SUBJECT: INCREASE OF THE SPENT FUEL POOL STORAGE CAPACITY

Re: R. E. Ginna Nuclear Power Plant

Amendment No. 65
License No. DPR-18

SAFETY EVALUATION

REGIONS OF ACCEPTABILITY AND UNACCEPTABILITY
FOR STORAGE OF SPENT FUEL IN REGION 2

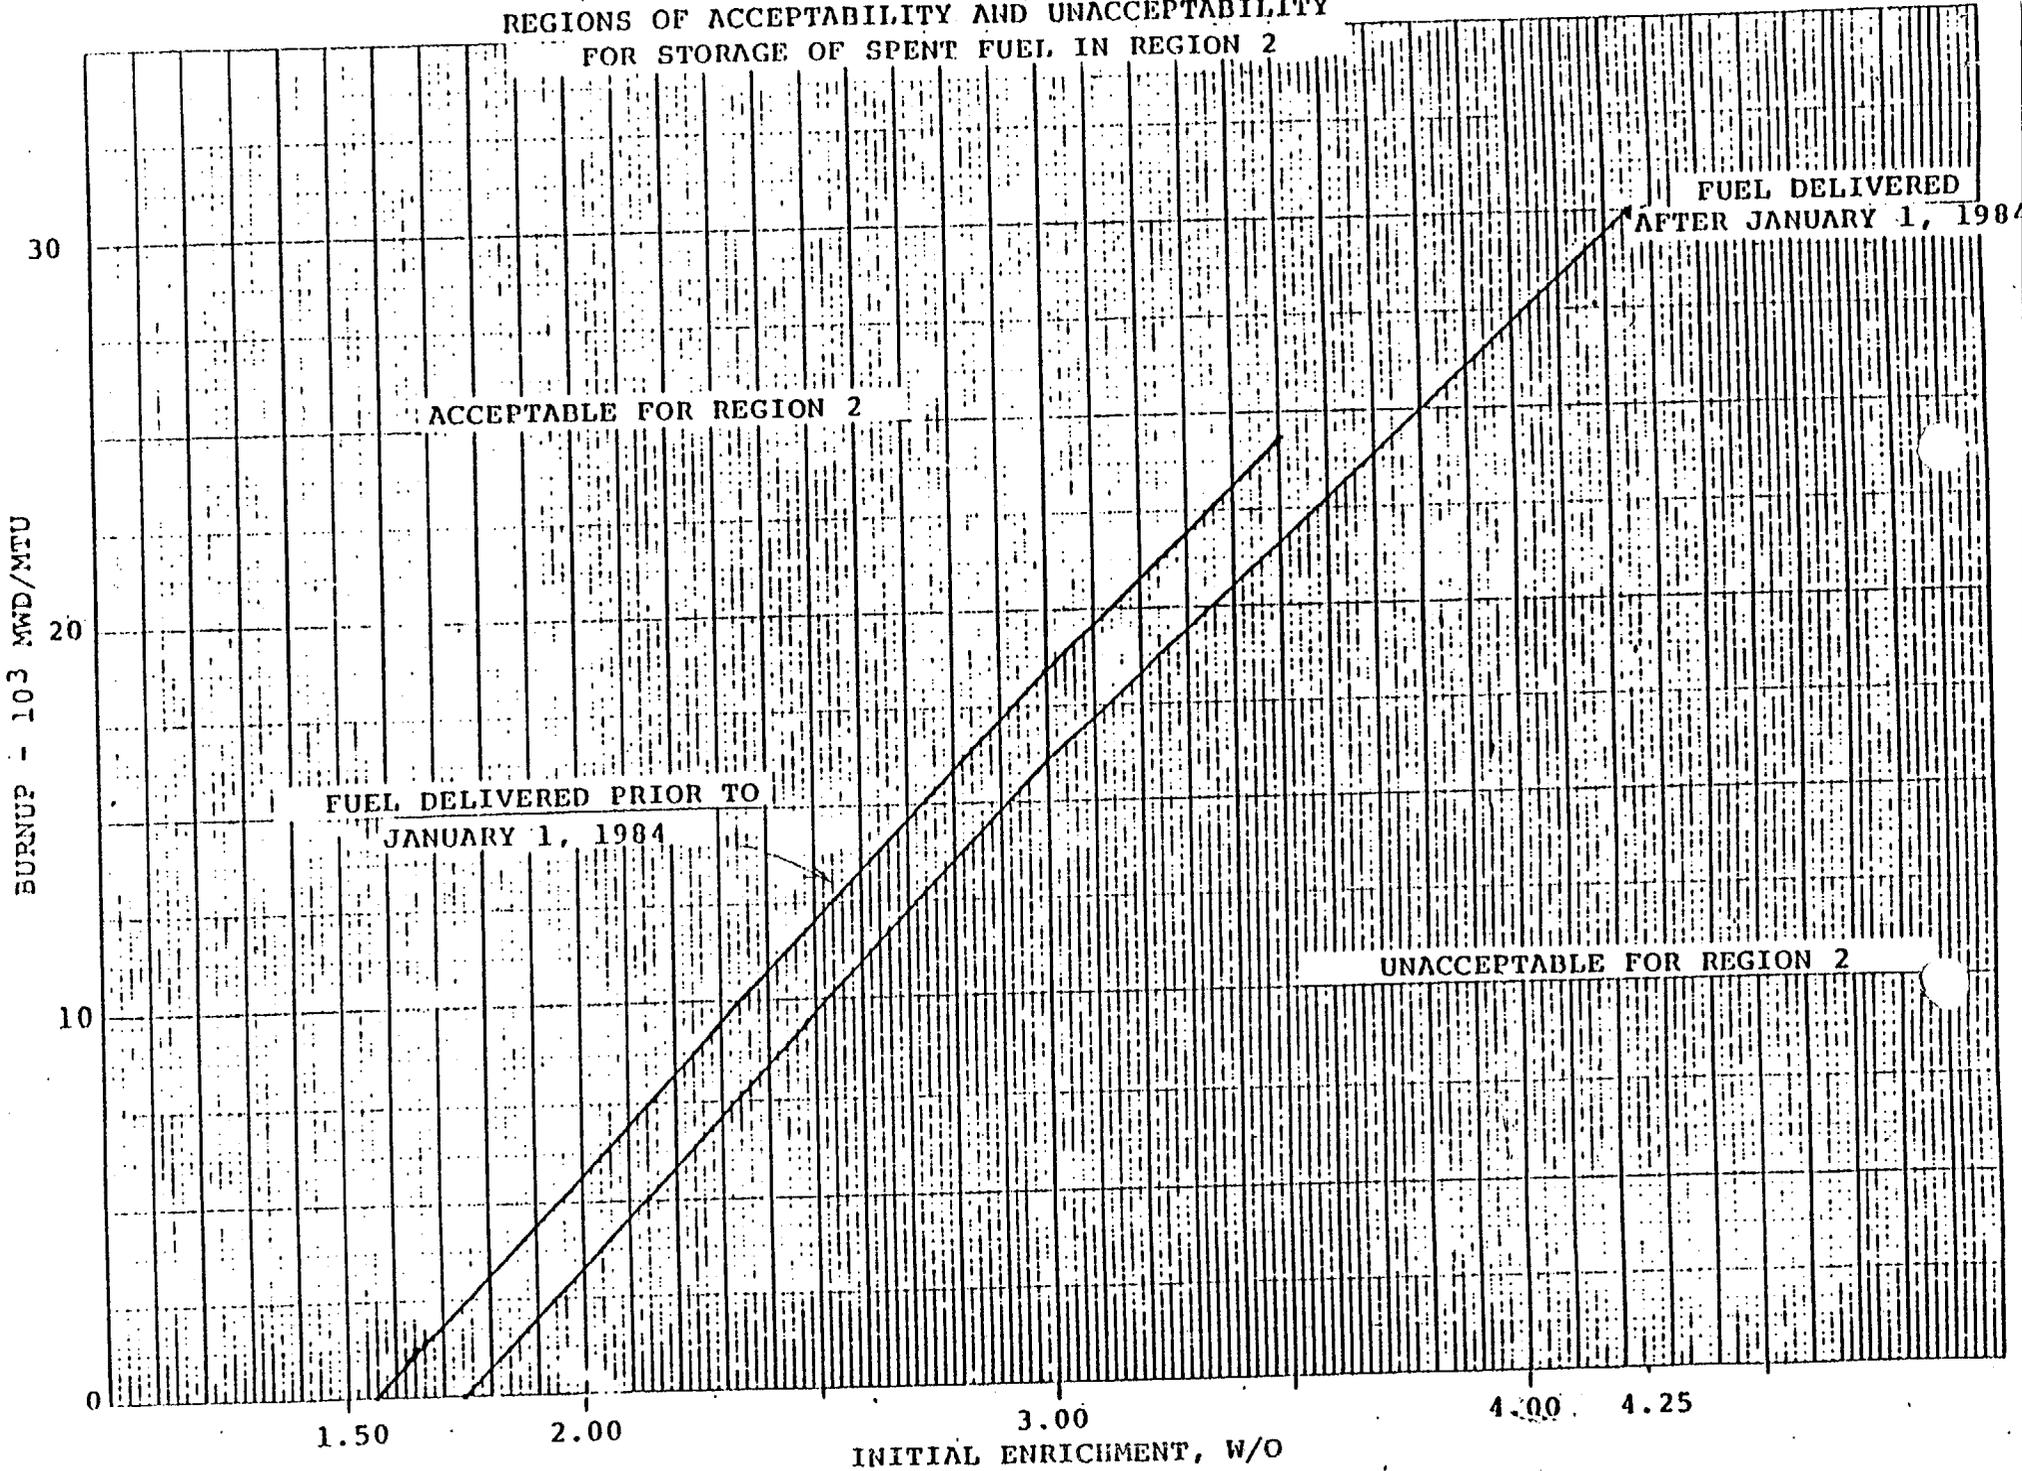
1. 60 days must have elapsed since the reactor reached hot shutdown.
2. The combination of the assembly average burnup and the initial U-235 enrichment must be such that the point identified by the two parameters on Figure 5.4-2 of the April 2, 1984 submittal is above the line applicable for the particular fuel assembly design. This will assure that k_{eff} for the stored fuel is equal to or less than 0.95. To assure that the burnup has been properly established, the licensee indicates that the burnup of each assembly will be established using the Nuclear Fuel Accountability Code that was started in 1970. This code establishes the isotopic content of the fuel and other parameters such as burnup. This information along with the curves on Figure 5.4-2 of the submittal will be used to determine if an assembly can acceptably be stored in Region 2. The seismic analysis of the modified spent fuel storage racks incorporated higher loadings which would be expected for the case of rod consolidation. However, the licensee request of April 2, 1984 as supplemented June 12, 1984 requested approval only for storage of unconsolidated fuel.

The design is intended to contain any of the Exxon or Westinghouse HIPAR or OFA 14x14 fuel assemblies used in Ginna with an initial enrichment of up to 4.25 weight percent U-235 at an assembly average exposure of 30,000 MWD/MTU. For lower initial enrichments, the amount of exposure required for storage in Region 2 will be reduced. For 3.00 weight percent U-235, for example, it is 15,960 MWD/MTU and for 1.75 weight percent U-235, even fresh fuel can be stored in Region 2 as seen from Technical Specification Figure 5.4-2.

Figure 1. Pool Layout

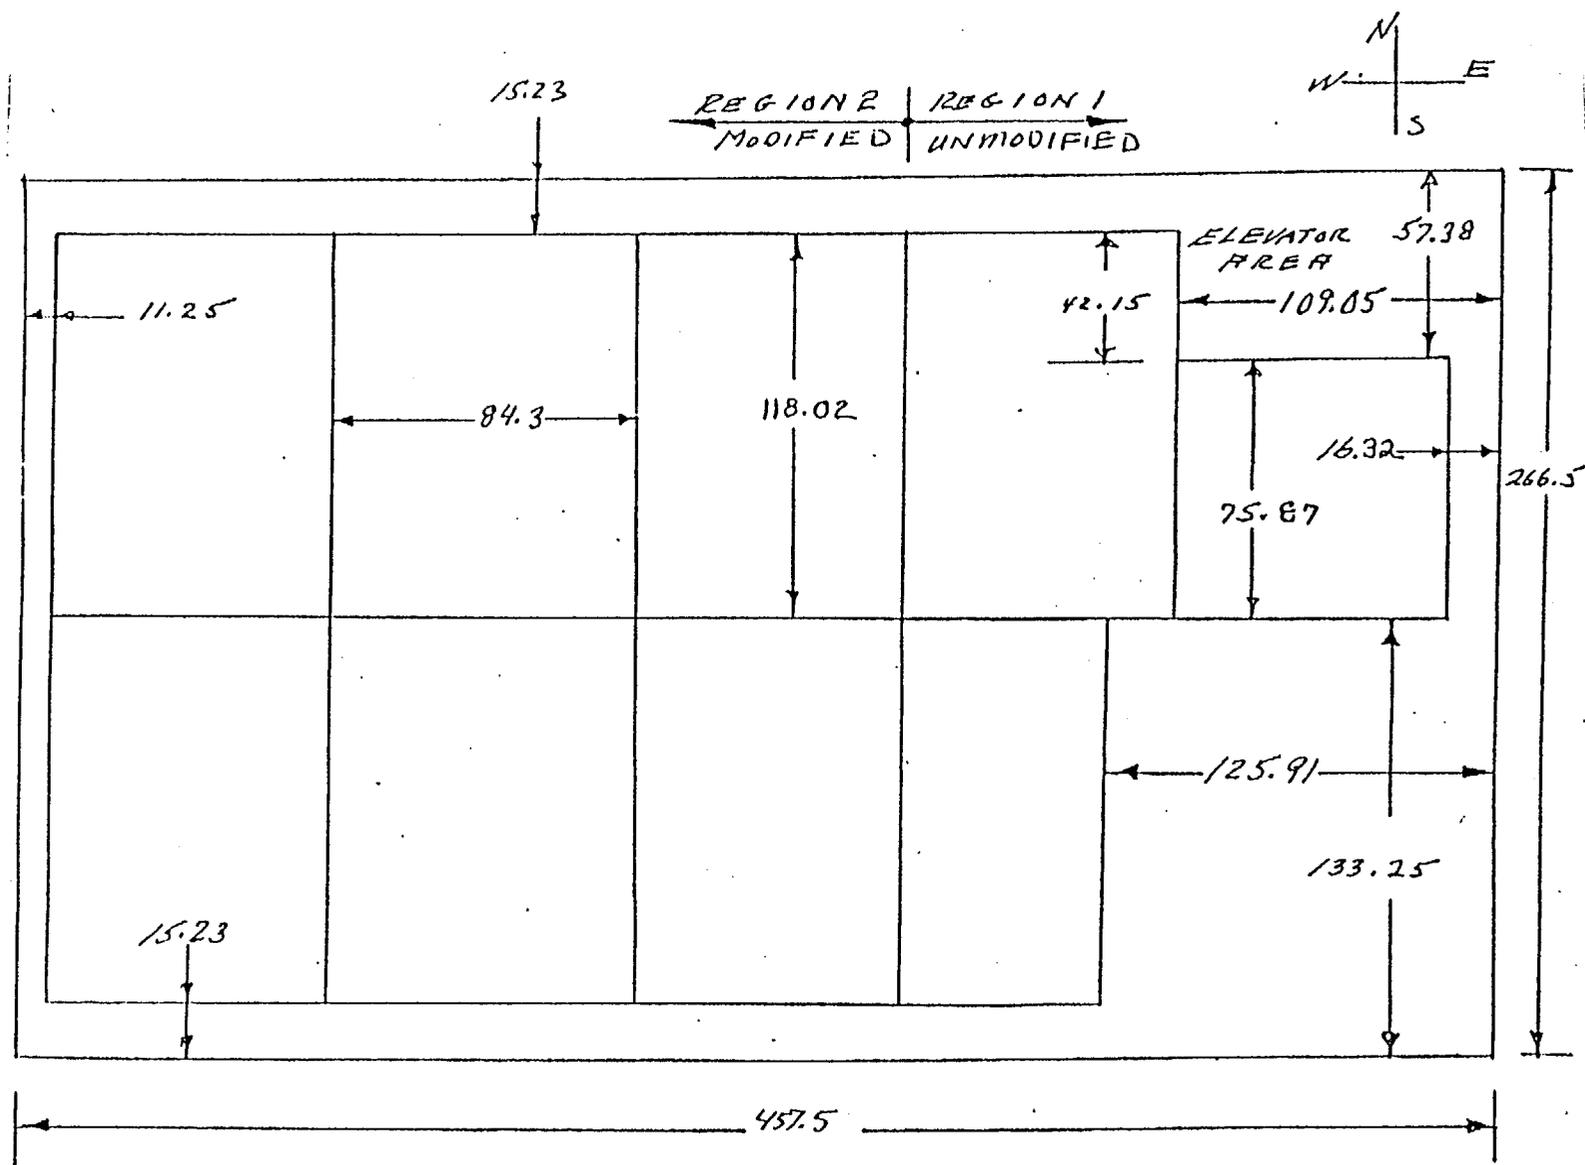
Only the six modules in Region 2, shown in Figure 1, are subjected to rerack modification [1]. All of these modules have identical cross-sectional dimensions, 84.3 in x 118.02 in. Modules having this design of nearly square cross sections generally behave in three-dimensional fashion in seismic events. Hence, the modules will exhibit three-dimensional nonlinear structural behavior under earthquake loadings, and all seismic analyses of modules should therefore focus on characterizing this behavior.

The pool layout shown in Figure 1 indicated that there is no gap between adjacent modules in the pool. The Licensee stated that, because of the strong hydrodynamic coupling effects in the case of no gap, adjacent modules were forced to vibrate in phase, thus precluding any impact between adjacent

Figure 2. RACKOE Model of Spent Fuel Racks

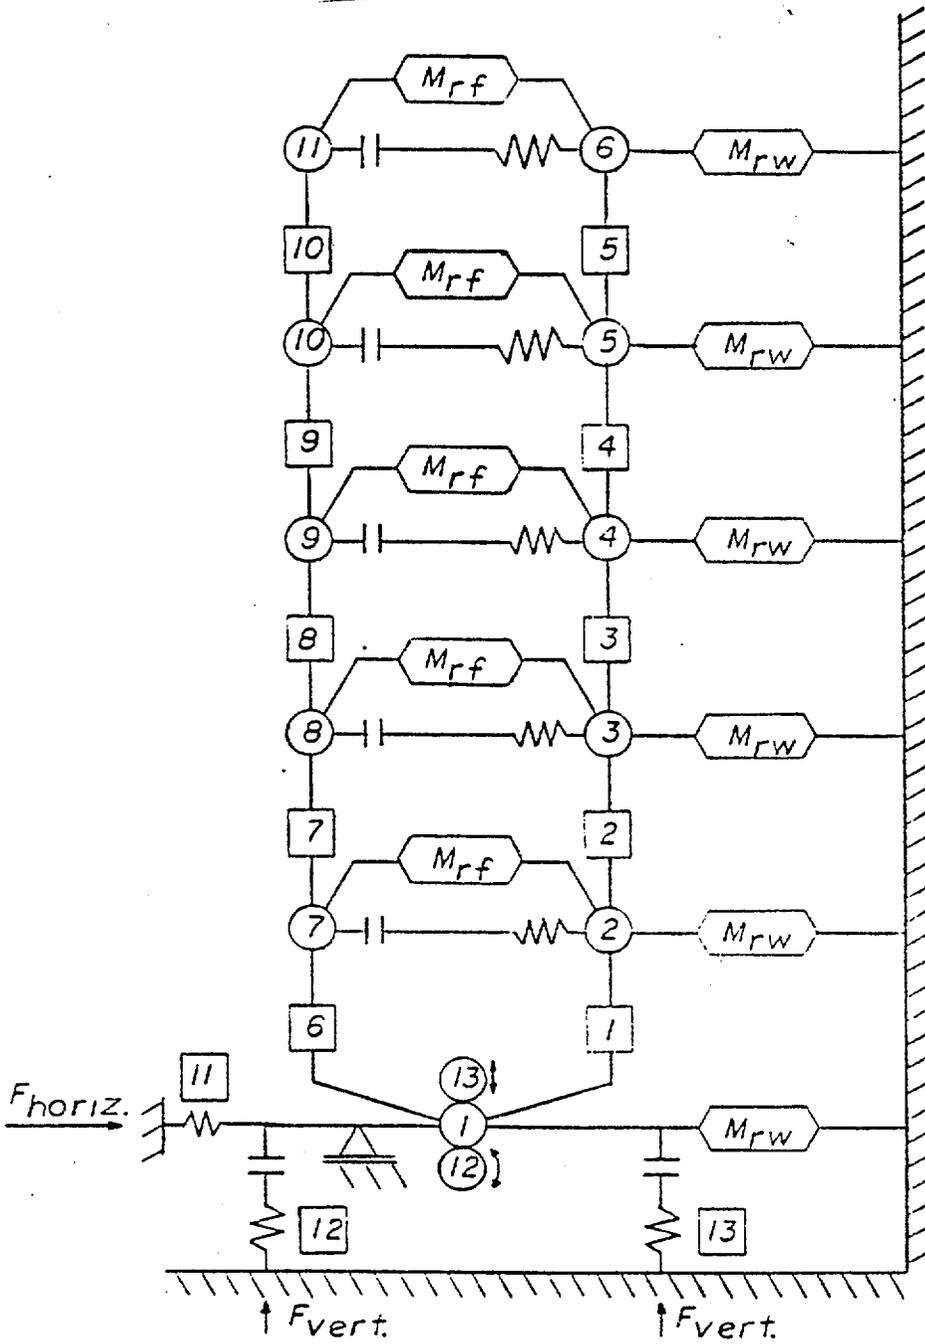
A two-dimensional nonlinear model was developed in accordance with the special purpose finite element program, RACKOE. This program was designed to solve the equations of motion explicitly using Euler's extrapolation formula. A schematic view of the RACKOE model is shown in Figure 2.

The assumption in Item c may be valid when adjacent modules are identically loaded, but an out-of-phase response will most likely occur for differently loaded modules, either empty, partially, or fully loaded.

The Licensee responded [5] by performing an impact analysis. The RACKOE model shown in Figure 2 was modified to include the compression-only springs at the top of the module to represent the presence of the adjacent module. The compressive force obtained in these springs was used to calculate the impact area on the wall of fuel cells based on the allowable compressive stress requirement. The length of wall required to resist the compressive force was calculated to be 16.0 inches in the east-west direction and 16.9 inches in the north-south direction. These impact wall lengths are acceptable since there is not much space between adjacent modules. The Licensee also demonstrated that the impact between adjacent modules would not adversely affect the stress distribution within the module structure [6].

Figure 3. Simplified RACKOE Model for Liftoff Analysis

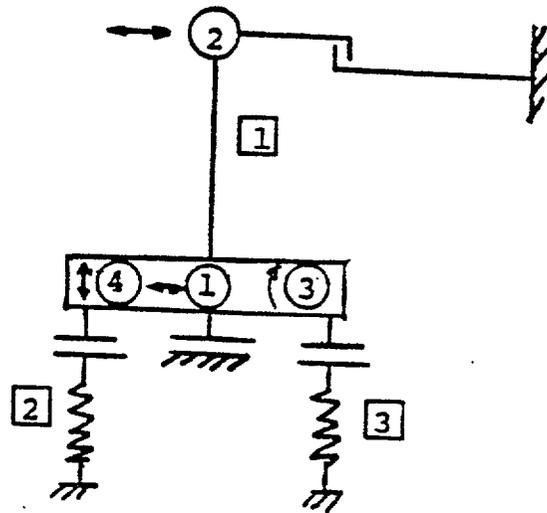
structure. A modified RACKOE model, shown in Figure 3, was used in this analysis [8]. This simplified model used a single mass to simulate the module and its contents. This approach basically assumes a stiff beam to represent the entire module. This assumption is reasonably valid because the module is very stiff in the vertical direction. Furthermore, the Licensee demonstrated that identical results were obtained from a model containing five concentrated mass nodes to represent the module structure and its contents [6].

For the operating life of the plant, the Licensee predicted that the maximum distance that the modules can slide is 0.95 in [4]. The closest obstruction, excluding adjacent modules, is the west wall which has an installed gap of 11.25 in. Consequently, the module sliding and tilting will not impact the pool wall. Since there is no gap between adjacent modules, this predicted sliding of modules will probably cause some form of impact between adjacent modules. As discussed in Section 3.2.3, an impact analysis was performed to insure that no damage was caused by the impact to the module structure and its contents.
